RS-02-013

Clinton Power Station, Unit 1  
Facility Operating License No. NPF-62  
NRC Docket No. 50-461

Subject: Response to Request for Additional Information Regarding Risk Aspects  
of Inclined Fuel Transfer System License Amendment Request for Clinton  
Power Station

FIGURE 1

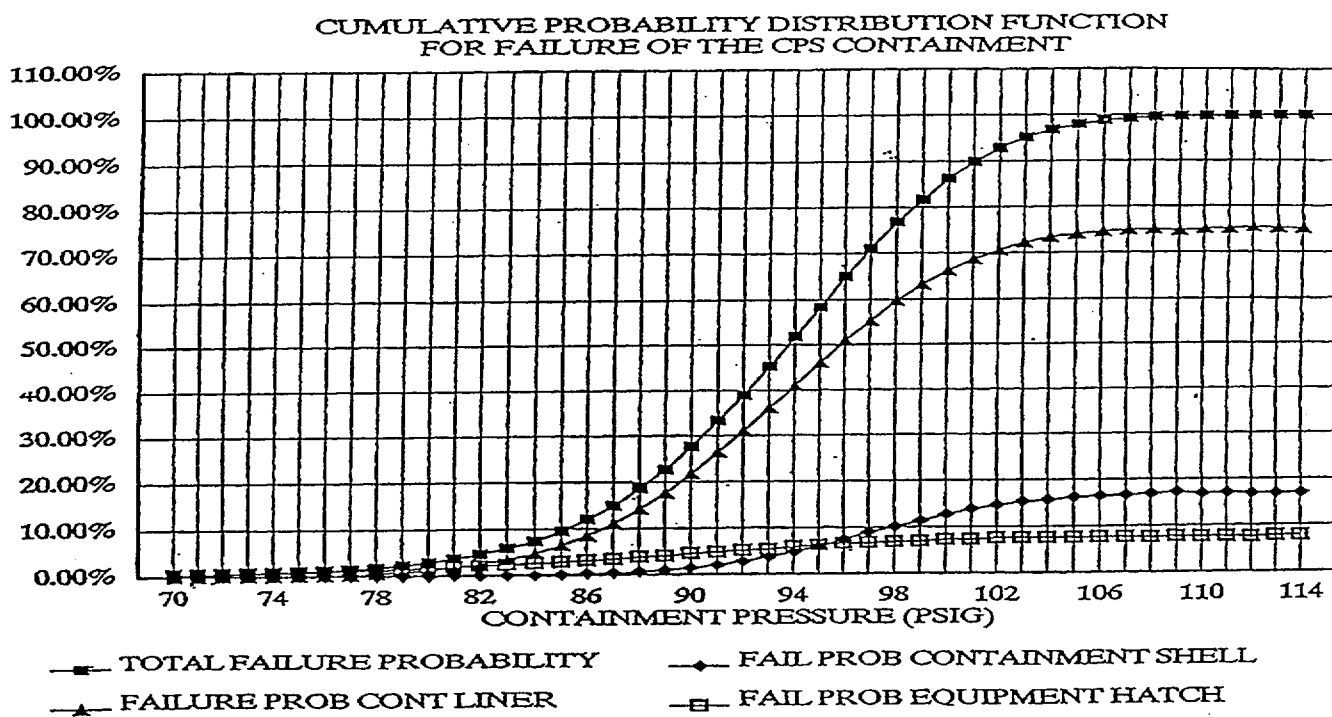
- b. the fragility curves (probability of failure as a function of containment pressure) for the major containment structures and penetrations (including the drywell, containment cylinder and dome, personnel airlocks, equipment hatches, and IFTS),*

- c. the composite fragility curve for the containment for the cases with the blind flange installed and the blind flange removed, and*
- d. the seismic fragilities (e.g., the HCLPF values) of the IFTS-related structures (transfer tube, bellows, drain line, and connected valves) and a comparison to the fragilities of the containment structure and penetrations.*

- b. Containment fragility curves were developed to estimate the containment failure probability as a function of containment pressure due to a number of potential containment failure mechanisms. These fragility curves are shown in Figure 1. The fragility curves do not include a failure mechanism for the drywell because the drywell is enclosed by the containment and because the drywell vent arrangement will limit the differential pressure across the drywell below pressures at which it would fail. The fragility curves do not include a failure estimate for the IFTS system either because, with the IFTS piping and IFTS flange rotated to the closed position, the pressure retaining capacity remains well within the capability of the other containment structures.

- c. The containment fragility curve with the IFTS flange in the closed position is addressed in the response to part b above. The containment fragility curve with the IFTS flange open but with the drain valve and bottom gate valve closed would also be the same as addressed in part b because the pressure rating of the IFTS tube and the valves is high enough that these elements would not be controlling. If the IFTS tube flange is open and the bottom gate valve is open the pressure retaining capability of the IFTS tube would be limited by the water head at the bottom of the IFTS tube provided by the spent fuel pool.
